COMMENT ON THE MARINE ECOLOGY REPORT

THYSPUNT NUCLEAR 1 DRAFT ENVIRONMENTAL 2nd DRAFT IMPACT ASSESSMENT REPORT

Prepared by: Trudi Malan on behalf of the Thyspunt Alliance

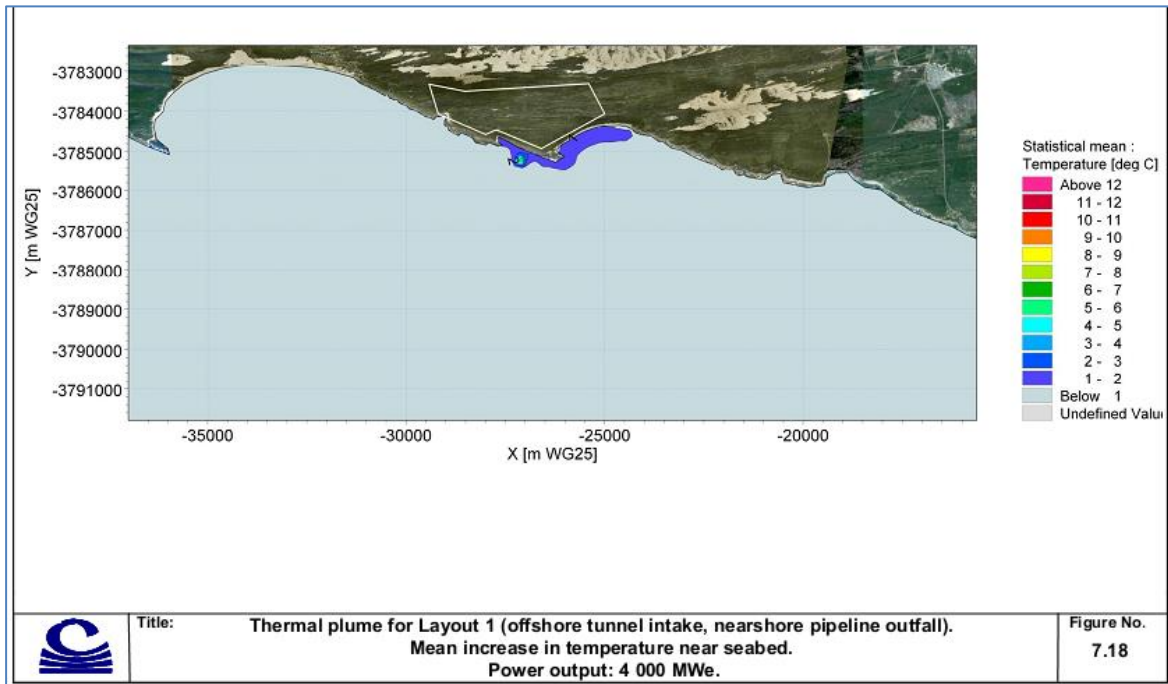
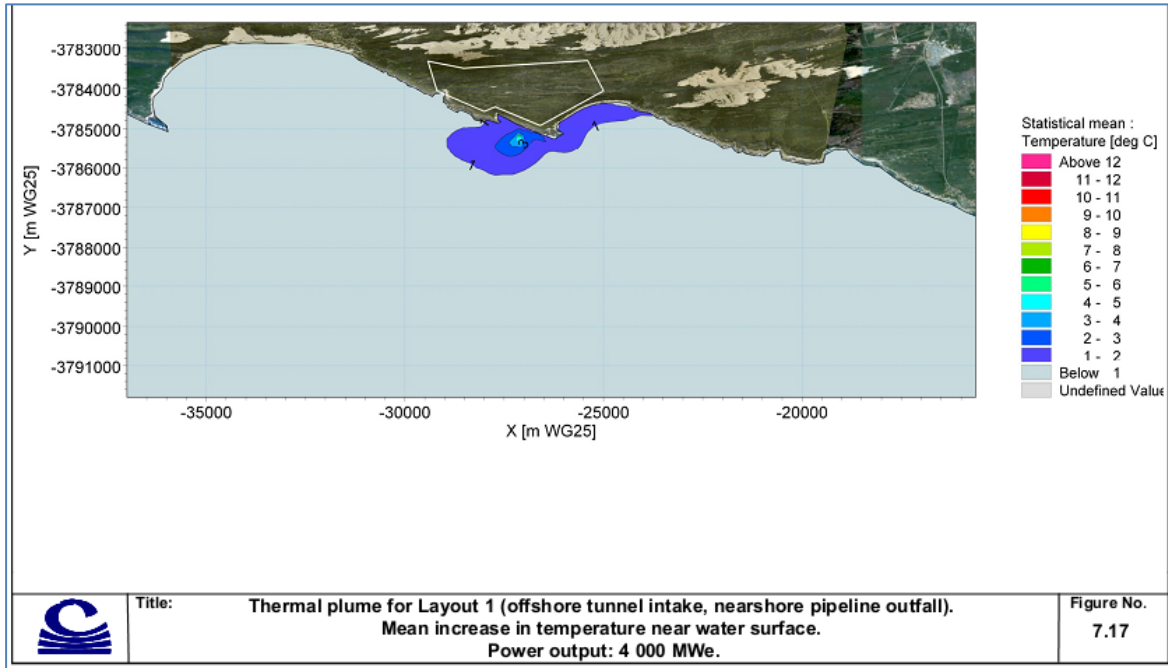
3.3.3 Release of warmed cooling water

No input of warmed water comparable to that of the proposed development exists along this section of coast. As this site lies at the warm end of the Agulhas Bioregion it could be argued that a portion of species occurring here may be near the upper end of their temperature tolerance range and hence could be particularly vulnerable to further temperature increase. Although theoretically possible, this is however, unsubstantiated.

The last statement in this paragraph is cause for concern. If this is theoretically possible the specialist should either substantiate the probability or follow the precautionary principle. Either way, the report should consider all possible impacts and if this impact is possible it should be discussed.

Assessment of the significance of an impact is based on a number of variables, including the nature, extent, duration, intensity, etc. as indicated in Chapter 7 of the previous Revised Draft EIR and the Annexure to Chapter 10 of this RDEIR Version 2. As indicated in the Marine Ecology Assessment (Appendix E15) and in the marine specialist's response below, the extent or scale of this impact is very small. Water will be warmed over such a small area that the impact in is not considered significant.

The marine specialist's assessment of the impacts is based on detailed modeling of the impacts on temperature that have been undertaken in the Coastal Modeling Report (Appendix E16 of the Revised Draft EIR Version 1). Refer to Figures 7.17 and 7.18 below, from this report, for an illustration respectively of extent of average sea surface and seabed temperate increases for a nearshore outfall.

In terms of the thermal tolerance limit: The impacts here will be strongly dependent on which type of outfall is selected and as stated, an offshore release in which the warmed water is released in a diffused manner at 35m depth, then rising upwards due to its lower density, will have low impact and is hence preferred. An inshore outfall will have a greater impact, but given the very small area affected is still not of great concern, even if some species are eliminated from this immediate area.
